Tesla, Inc. Service Bulletin	Replace Front Aft Links And Rear Upper Links, China	
SB-20-31-007 September 18, 2021		R1		
Classification		Section/Group	Mobile Service	
Recall Bulletin		31 - Suspension	Cannot Perform	
Model Year	Model	Country/Region	Version	
2014 - 2017	Model S	China	All	
The model(s) and model year(s) listed are a general approximation of the affected VIN list. Refer to the VIN/Bulletin Tracker or Customer/Vehicle profile to determine applicability of this bulletin for a particular vehicle.

This Service Document supersedes SB-20-31-007, dated October 23, 2020. Each content change is marked by a vertical line in the left margin. Discard the previous version and replace it with this one.

Figure 3 – Bolt head facing away from the HV battery (LH shown, RH similar)

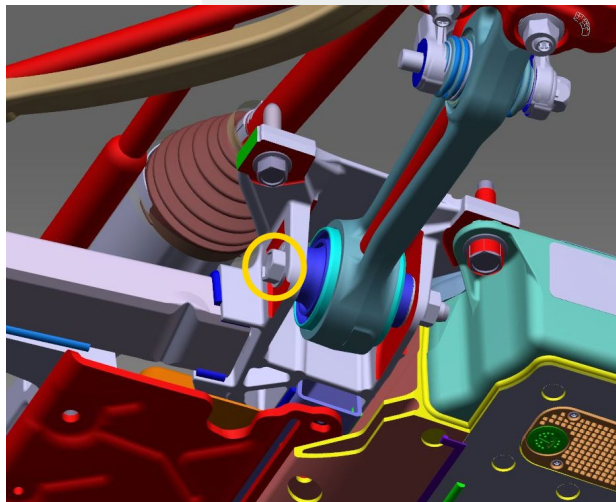
5. Inspect the bolts that attach the LH and RH front aft links to the front subframe (Figure 3).

- If **both** bolt heads are facing away from the HV battery (Figure 3), continue to step 12.
- If only one aft link needs replacement, and the bolt head attached to that aft link is facing away from the HV battery, continue to step 12.
- If a bolt head is facing toward the HV battery, and the front aft link attached to that bolt needs replacement, continue to step 6.

**NOTE:** Make sure the new front aft link to subframe bolt(s) are installed with the bolt head facing away from the HV battery.
